Product Safety Notice

PRODUCT DESCRIPTION: Beretta ARX100 5.56mm.

FIGURE I

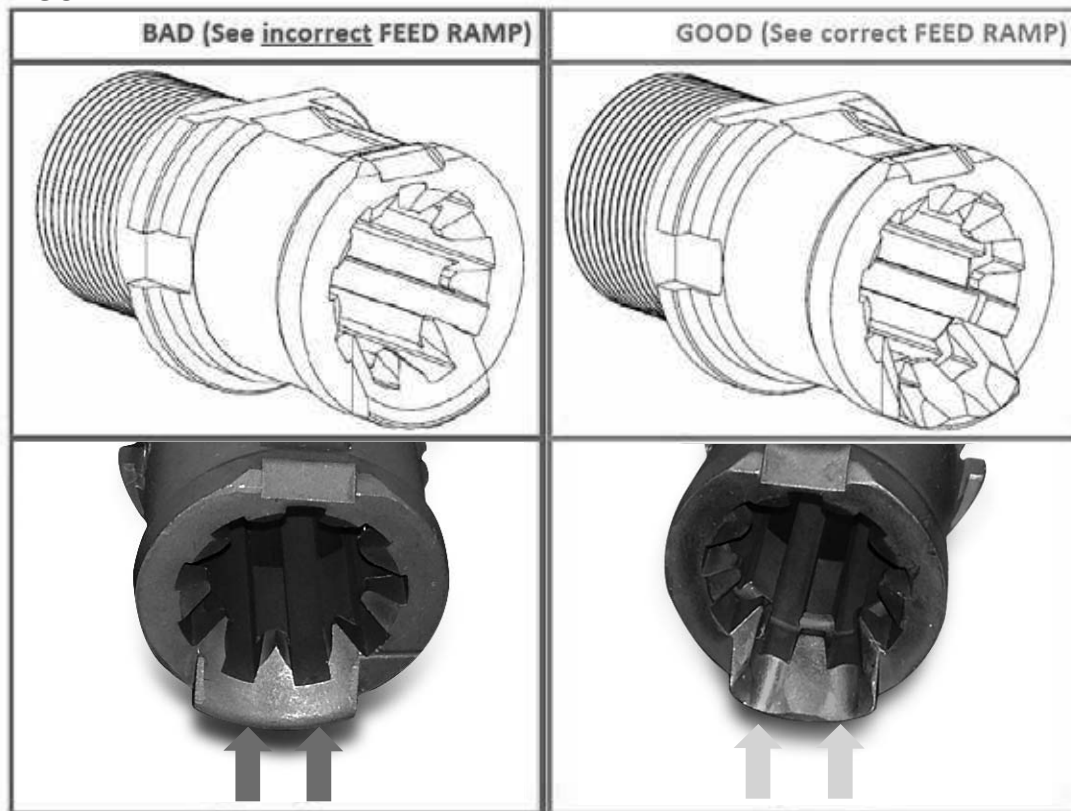
STEP I - Ensure that you have the proper feed ramps. (SEE FIGURE I)

If your ARX100 barrel extension looks like the one on the left (RED) then you have a bad barrel extension and you should contact Beretta Customer Service immediately (800) 237-3882. EXT 2003
